# FINAL CLOSURE & RECLAMATION PLAN

## **BLAZON No.1 MINE**

FINAL CLOSURE AND RECLAMATION PLAN  
BLAZON NO. 1 MINE, CARBON COUNTY, UTAH  
LIST OF EXHIBITS  
VOLUME 2

Re: Response to July 25, 1985 Technical Review Questions  
Final Reclamation of Blazon No. 1 Mine

Figure 1  
RECLAMATION SCHEDULE

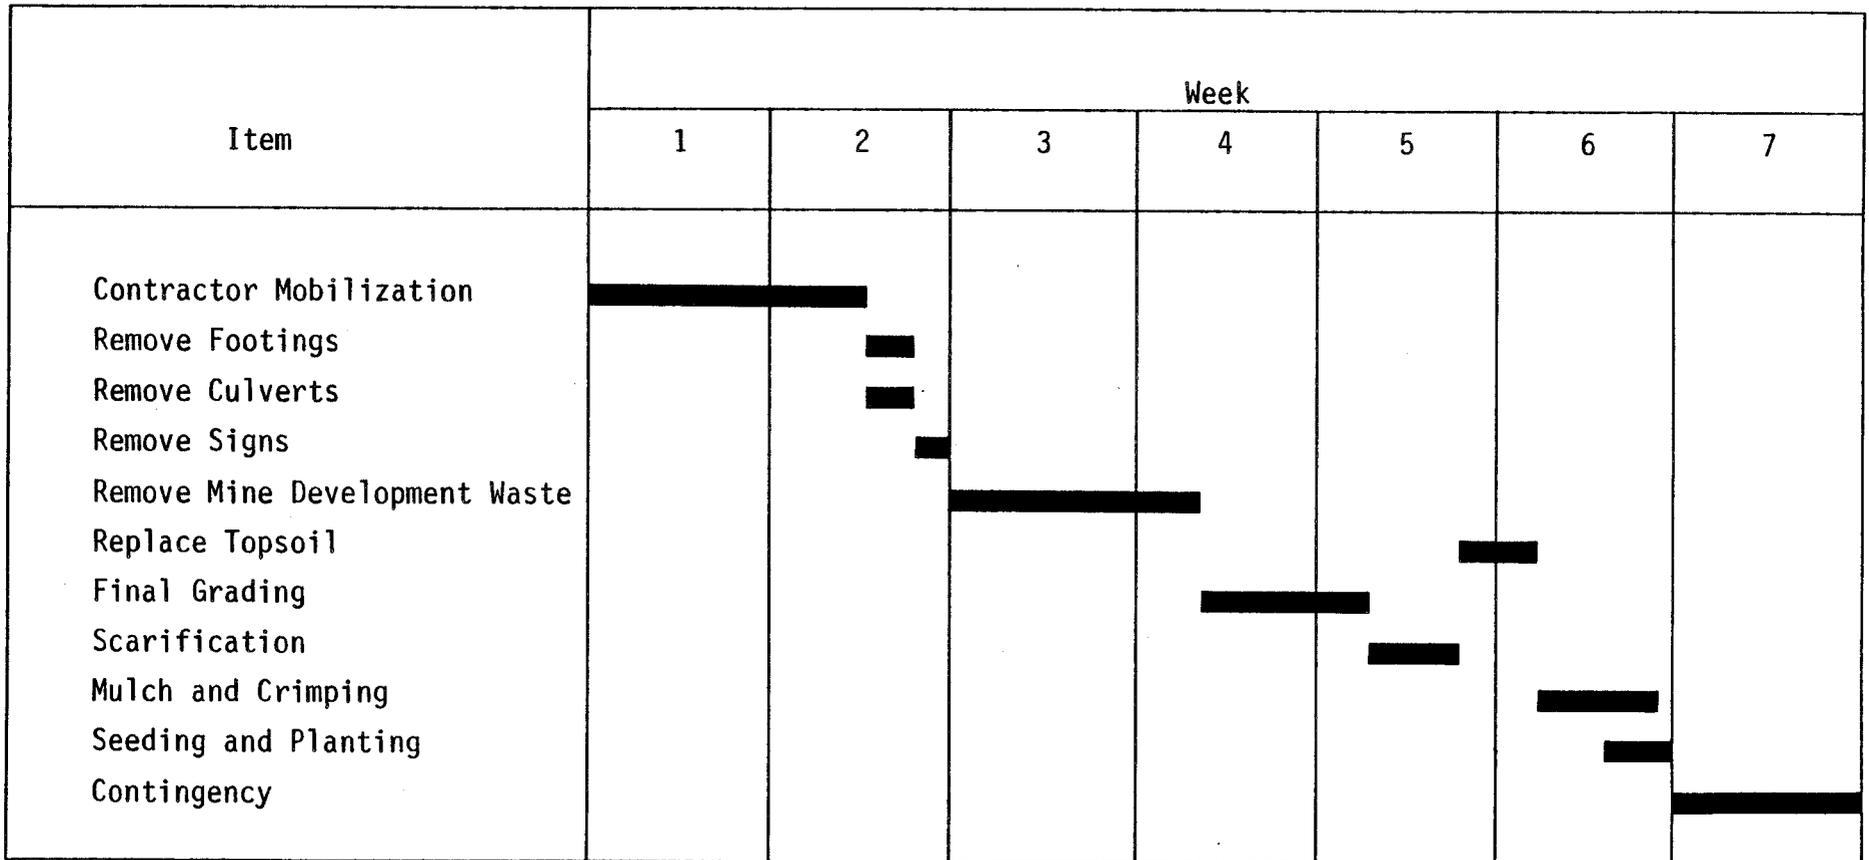
(b)(1) The applicant has not provided a schedule for the reclamation of the lands within the proposed permit area. The reclamation plan requires a detailed timetable of each major step in the reclamation plan. This can be accomplished by providing a bar chart on a weekly schedule for the reclamation construction. Timing can be accomplished by notifying the Division within 30 days of commencement of the reclamation construction work.

In order to further clarify the reclamation schedule, NAE has attached Figure 1, Reclamation Schedule, to provide UDOGM with a more specific schedule. We have hesitated to put exact dates on the schedule as we are unsure as to the timing of approval by UDOGM; however, we have blocked out reclamation activities by week. In addition, we plan to begin immediate reclamation work upon approval by UDOGM.

Figure 1.  
CULVERT D' CALCULATIONS

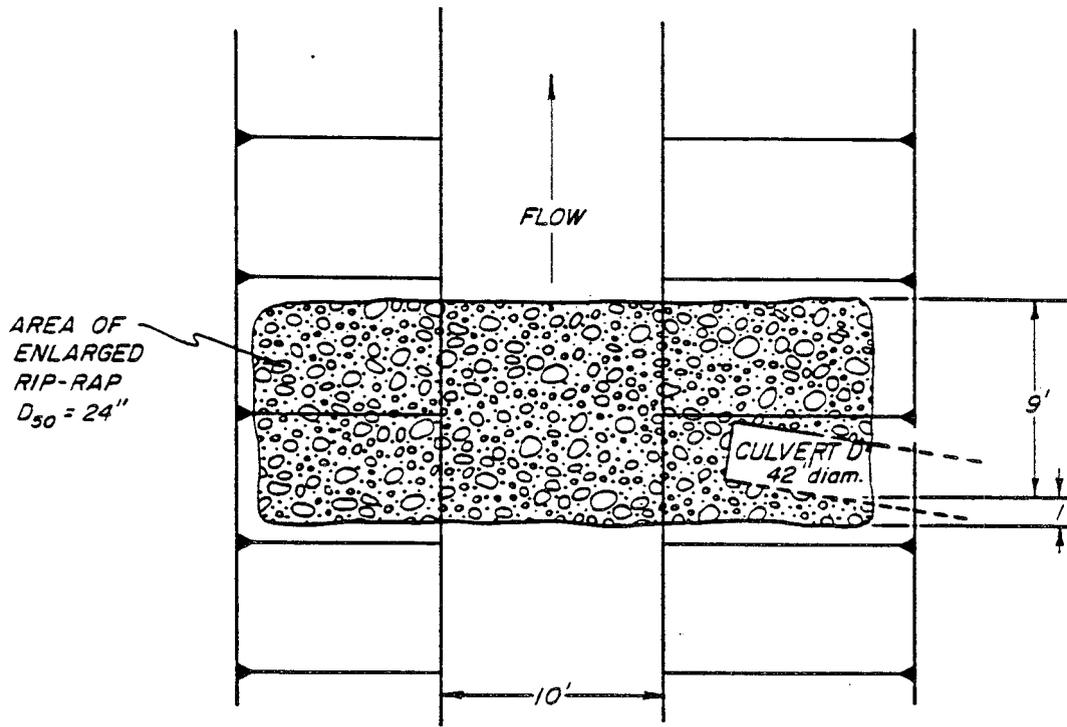
5. Item 12) - Culvert B - 84" diameter CMP. The pre-existing mine plan indicates that the culverts in Mud Creek were designed for the 50-year, 24-hour event. In the event that the culvert is not adequately sized for the 100-year, 24-hour event or cannot be designed to meet the peak flow, NAE should consider removal of this culvert. Removal would allow for re-establishment of open channel flow from the ephemeral channel currently diverted by culvert "D". Additionally, the possibility of relocating culvert "B" next to culvert "C" which in tandem may provide the required discharge capacity should be investigated.

RESPONSE: NAE has calculated the peak flows per the attached calculations. The design event has been determined to be the 50-year, 24-hour precipitation event based on the fact that no channel diversion exists. Culverts B and C are capable of passing the design event as demonstrated in the attached calculations. Culverts B and C will be left in place. The existing culvert D will be supplemented by the installation of a parallel culvert identified as Culvert D'. Culvert D' will be a 42" diameter corrugated metal pipe. Design calculations for Culvert D' can be found Figure 1, Culvert D' Calculations.

CULVERT D' OUTLET DETAILS

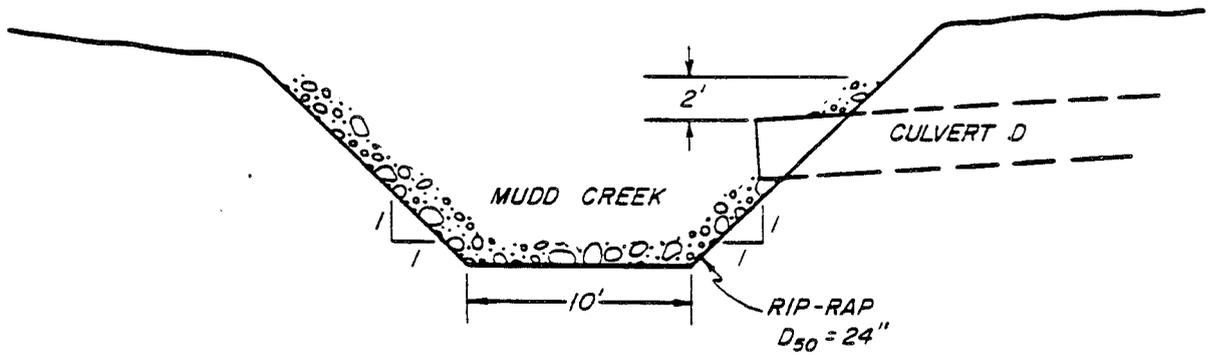
4. Item 14) - Culvert D - 24" diameter CMP. Removal of the upper half of the culvert will require design of a headwall facility to carry the water under the lower pad. In the event that the culvert cannot be designed to handle the 100-year, 24-hour event, it is recommended that the culvert be completely removed and that open channel flow be established. Consideration during design of the headwall for the culvert should also taken into consideration the tendency for mud and debris flows in the ephemeral channel. The reclamation plan should consider what maintenance

installed in this area. Figure 2, Culvert D' Outlet Details shows the configuration of the riprap to be installed in the Mudd Creek channel at the outlet of the 42" diameter culvert.

Figure 4  
Culvert A Channel Restoration

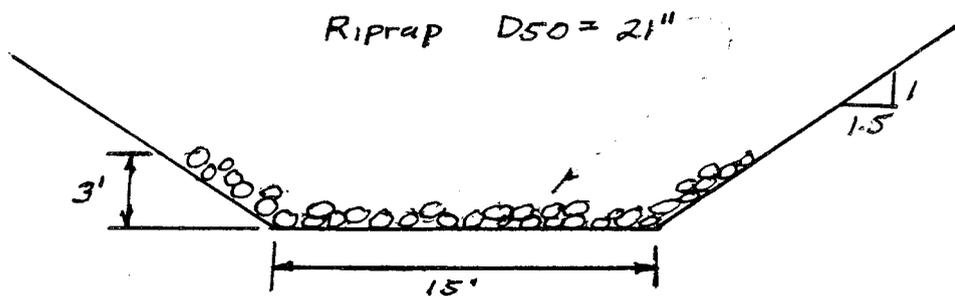
The applicant must include plans for the reclamation of the channel bank after the removal of the culvert. These plans must include recontouring of the bank and design for rip rap protection. The applicant must also state when the culvert will be removed. Figure 1 in the August 8, 1985 correspondence from NAE indicates the culvert will be removed prior to any grading or seeding. The response to UMC 817.44(c) on page 14 indicates that the culvert will be removed following topsoil and reseeding of the portal bench area. The applicant must also include what time of year the culvert will be removed.

Culvert A will be removed. The channel configuration in the area of the removed Culvert A will be as shown on the Figure 3, Culvert A Channel Restoration. The channel configuration determined for the restored channel in the vicinity of Culvert A was determined from Figure 4, Culvert A Channel Calculations.

RESPONSE: NAE plans to remove Culvert A as shown on the Reclamation Plan Map (Map 2). This culvert is approximately 25 feet in length. NAE plans to gain access across culvert A to the portal for reclamation work. After reclamation work is completed on the portal area, NAE plans to remove culvert A. Thus, culvert A will be removed during the late fall of 1985 following topsoiling and reseeding of the portal bench area. Culvert A channel reclamation is shown on Figure 4, Culvert A Channel Restoration.

Figure 5  
DITCH B DESIGN CALCULATIONS

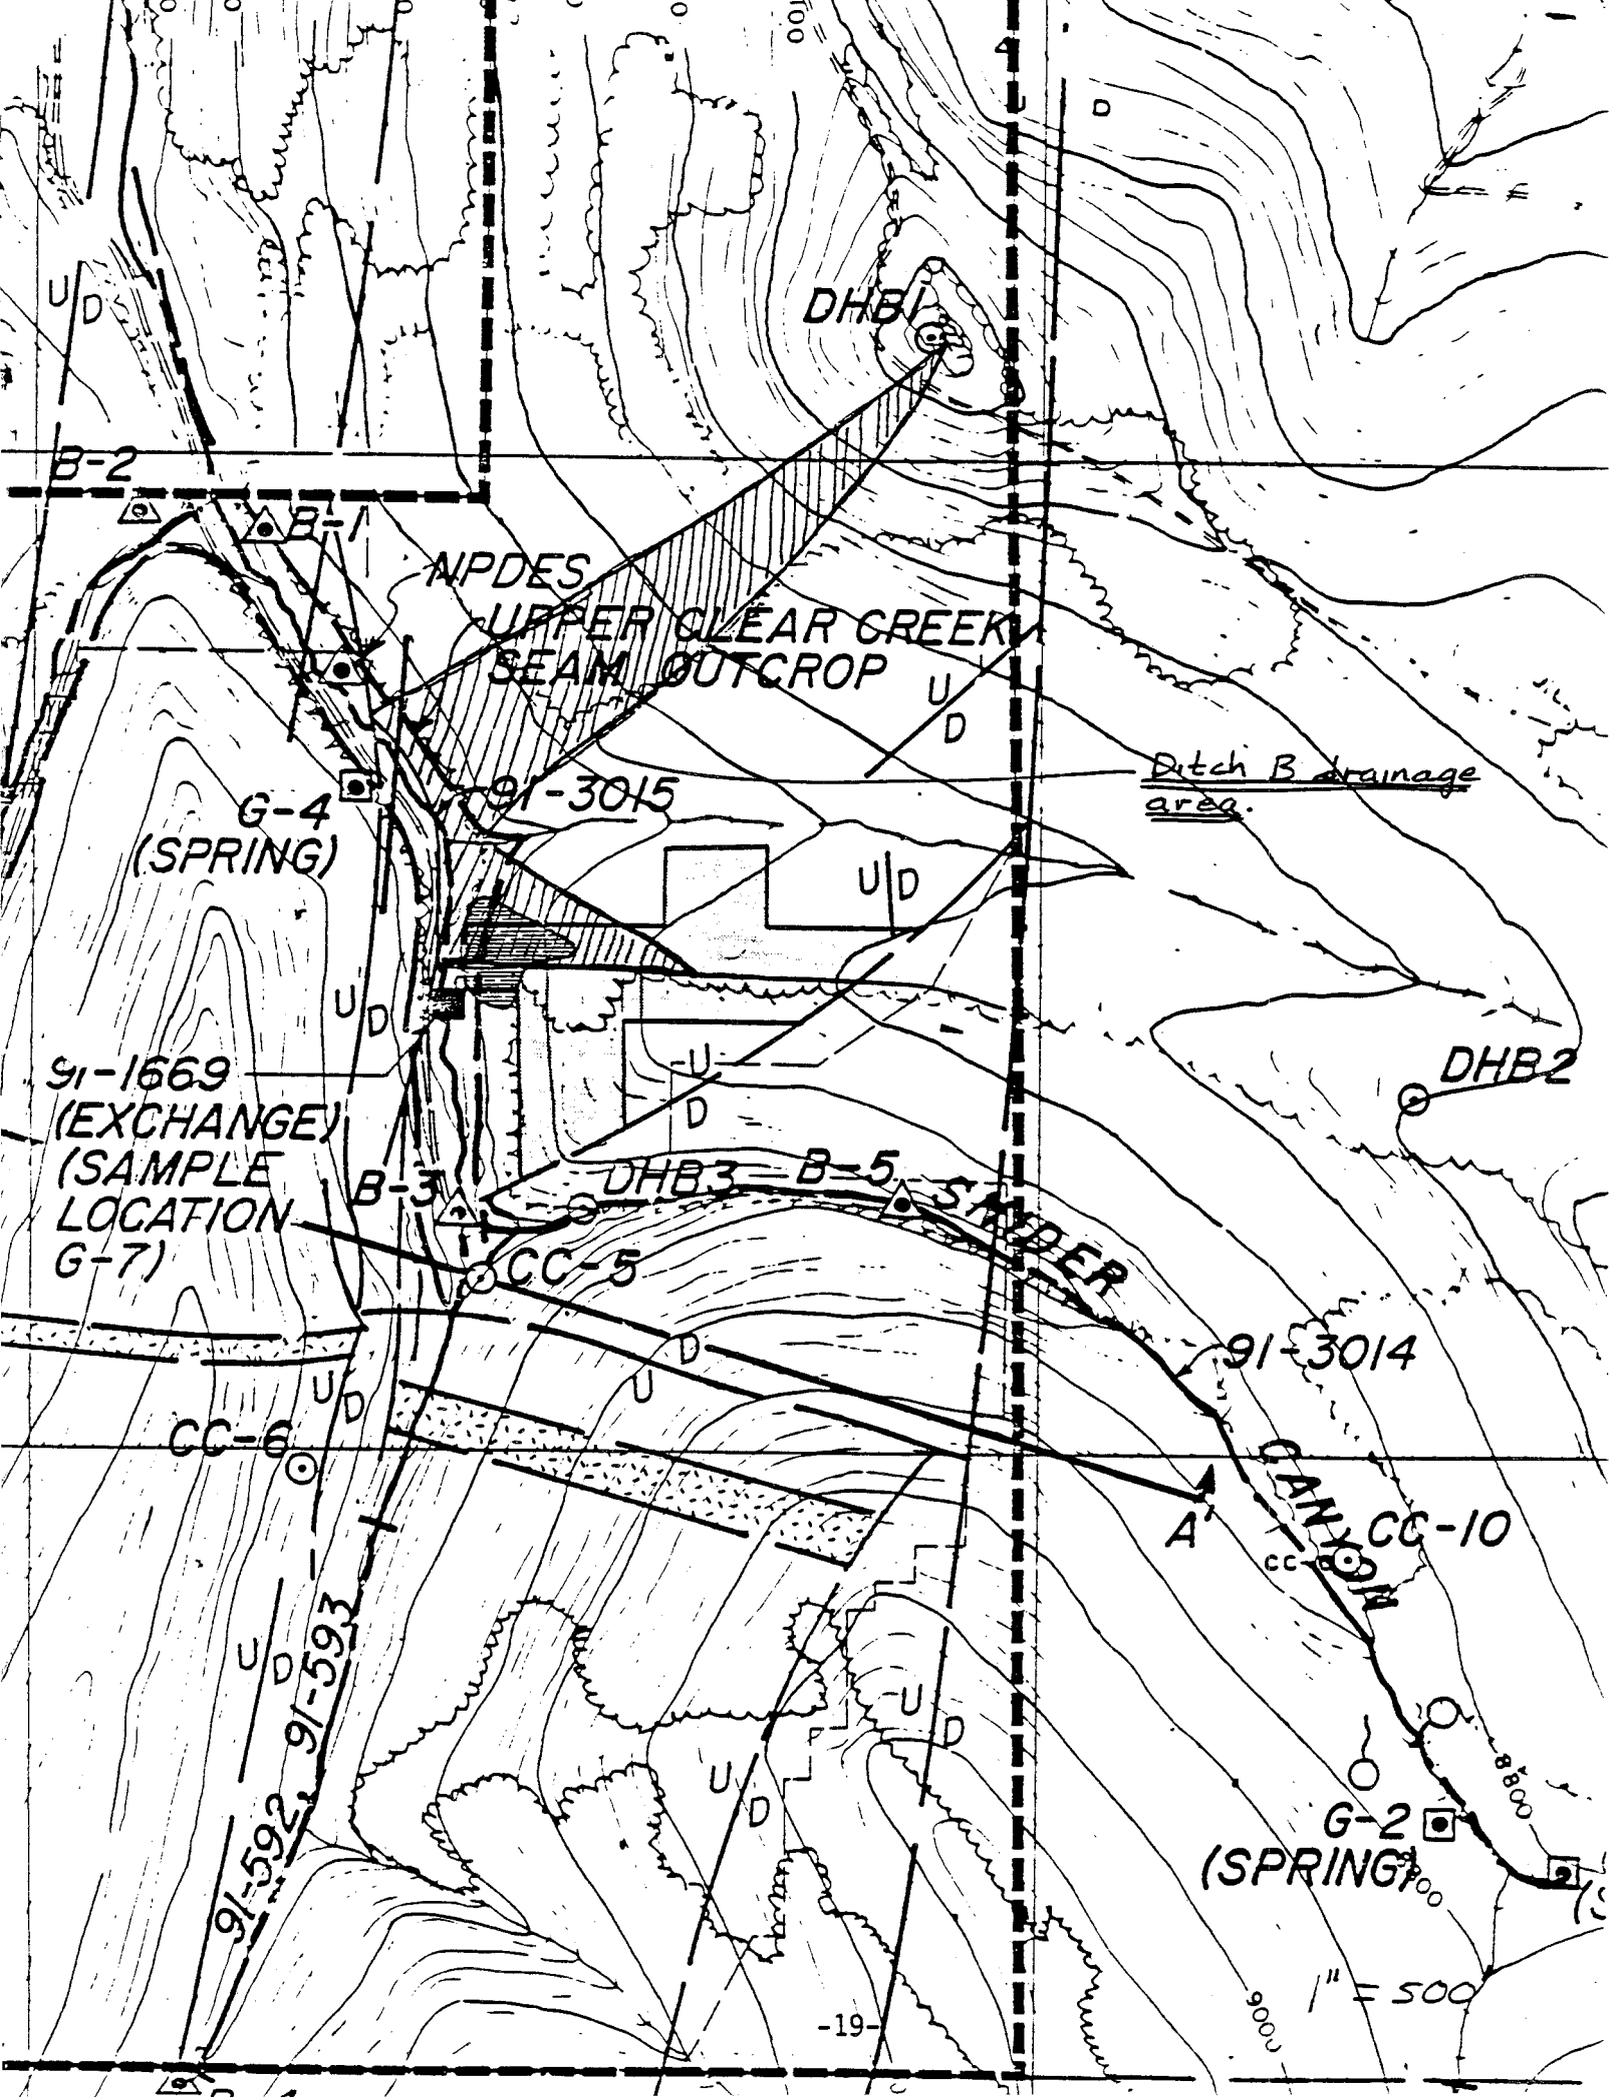
- (b) The applicant needs to provide calculations that show the disturbed drainage diversions (items #19 and #20 on Map 2 of the Reclamation Plan) are capable of passing the 10-year, 24-hour precipitation event.

RESPONSE: Peak flow calculations indicate that Ditch B will be required to pass 5.2 cfs during the 10 year, 24 hour precipitation event. Based on this 5.2 cfs, Ditch B has been designed per Figure 5, Ditch B Design Calculations. The drainage area for Ditch B is shown on the following page.

Design calculations on this ditch have resulted in a ditch design as shown on Figure 6, Ditch B Design. The design of Ditch B requires that

FIGURE 7

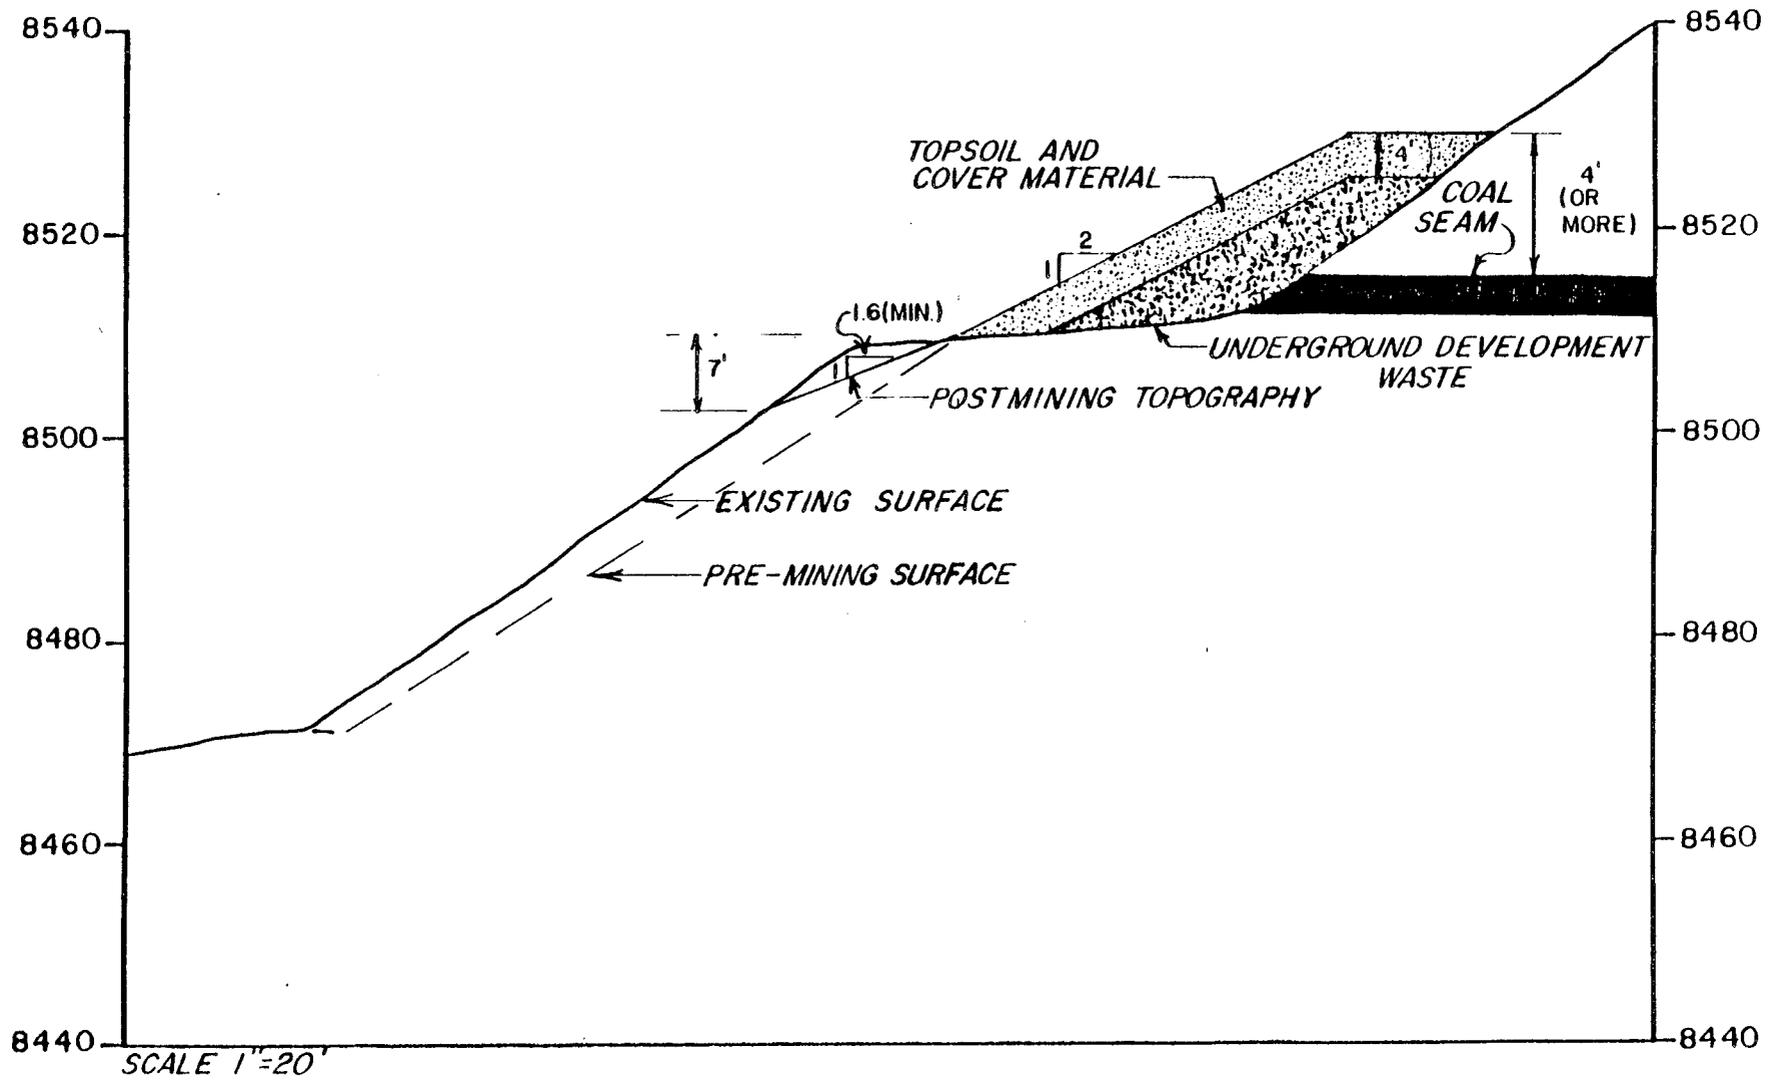
The applicant has not adequately responded to the comments concerning backfilling and grading. Postmining contours of the area are virtually unchanged from those seen currently on the site at present. The portal bench area will be highly visible and will not meet the requirements for Approximate Original Contours. The applicant shall submit a new contour map showing a more suitable relief of the area with slopes not exceeding those found on the site during premining conditions. Where possible, the slopes shall be reduced to a minimum to enhance vegetation growth and to reduce erosion during establishment of vegetative cover.

1. Utilize underground development waste to cover the portals with a minimum of four feet (4') above the coal seam as shown on Figure 7, Typical Section Reclaimed Mine Bench. Place in lifts of one (1) to
